PLANNING BOARD REPORT PORTLAND, MAINE

Hotel Redevelopment
1210 Brighton Avenue
Level III Site Plan Review
2014-220
Portland Hotels, Inc., Applicant

Submitted to: Portland Planning Board Public Hearing Date: April 14, 2015 (<i>tabled from March 24, 2015</i>)	Prepared by: Nell Donaldson, Planner Date: April 8, 2015 CBL: 265-A-001
--	---

Figure 4: 1210 Brighton Avenue site plan

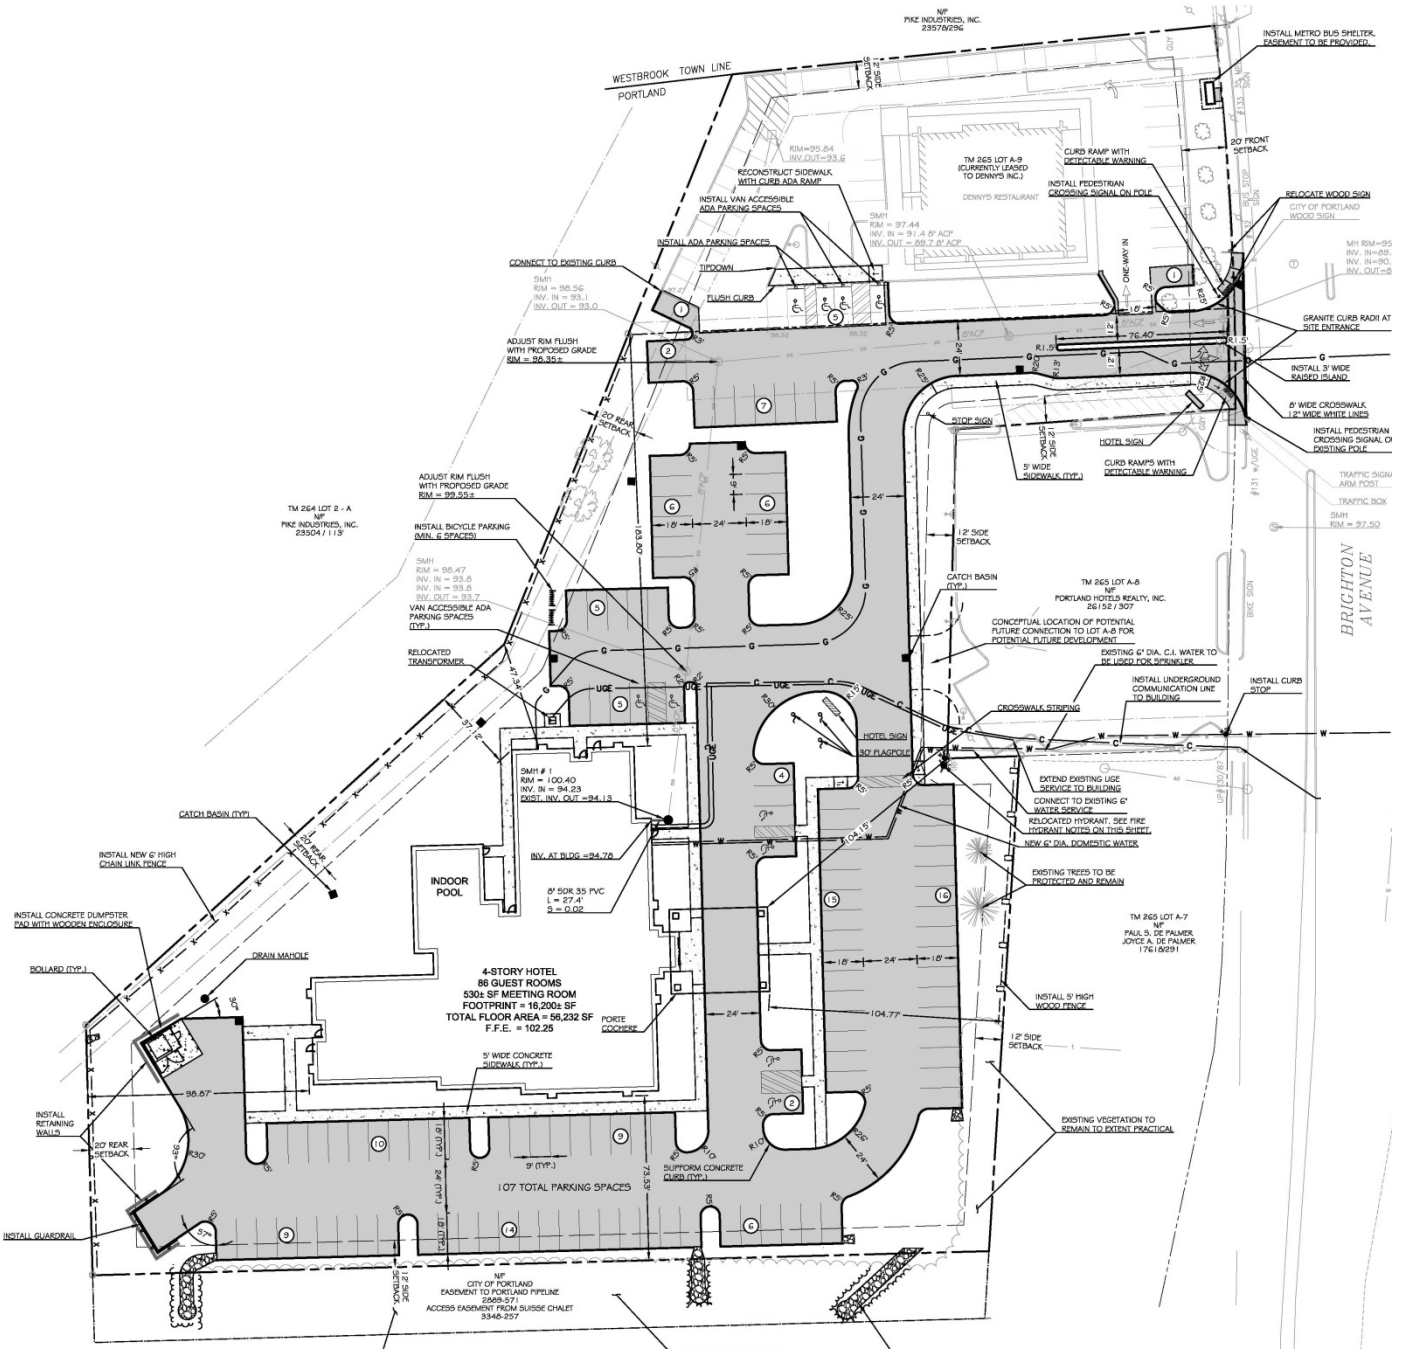
Vehicular access is proposed via a private driveway which forms the fourth leg of the Brighton Avenue/Riverside Street intersection. This drive also serves as the sole vehicular access for Denny's. The applicant proposes a 75' island at this entrance in order to reduce potential vehicular conflicts with cars exiting from Denny's. The applicant complied with staff requests to relocate existing Denny's parking spaces currently positioned on the entrance drive in order to further improve the safety at the site entrance. The applicant also provided a detailed pavement marking plan for the entrance drive at staff's request (*Plan 20*).

Internally, vehicular access and circulation has generally been designed in accordance with the city's Technical Manual, with the drive directing guests to the main entrance under the porte cochere. At staff's request, the applicant has configured the circulation system with the intent of providing future access to the adjacent Brighton Avenue sites in keeping with best access management practices; the applicant has noted a conceptual location for access into the former Mobil site.

Over the course of the review, staff requested minor circulation modifications with respect to the 12 space parking area to the west of proposed hotel, suggesting that these spaces might be relocated to the access drive in order to achieve a more efficient parking arrangement. The applicant has elected not to make this change in favor of "keeping parking spaces separated from the adjacent current and potential future businesses" (*Attachment U*). It should be noted that in their final submittal, the applicant reduced the size of this parking area by eight spaces. Mr. Errico has stated that he finds the final plans to be acceptable (*Attachment 1*).

Pedestrian access to and from the site is proposed via a sidewalk, located on the eastern side of the driveway, which connects to all proposed building entrances. This sidewalk would link to both the Brighton Avenue sidewalk system and the Brighton Avenue crosswalk, which traverses the eastern leg of the Brighton Avenue/Riverside Street intersection and from there provides access to nearby food and shopping in Westbrook. Mr. Errico requested that the applicant provide a crosswalk across the site driveway at Brighton Avenue. The applicant shows this crosswalk in their final plans. In his final comments, Mr. Errico notes,

Because the driveway is designed offset from the hotel's main door, lying approximately 500 feet, via the sidewalk, to the west, Mr. Errico has noted the probability that guests will seek ways to shortcut through adjacent properties when accessing the site by foot, especially when heading to or coming from the east. A future pedestrian connection through the Mobil site was discussed with the applicant.
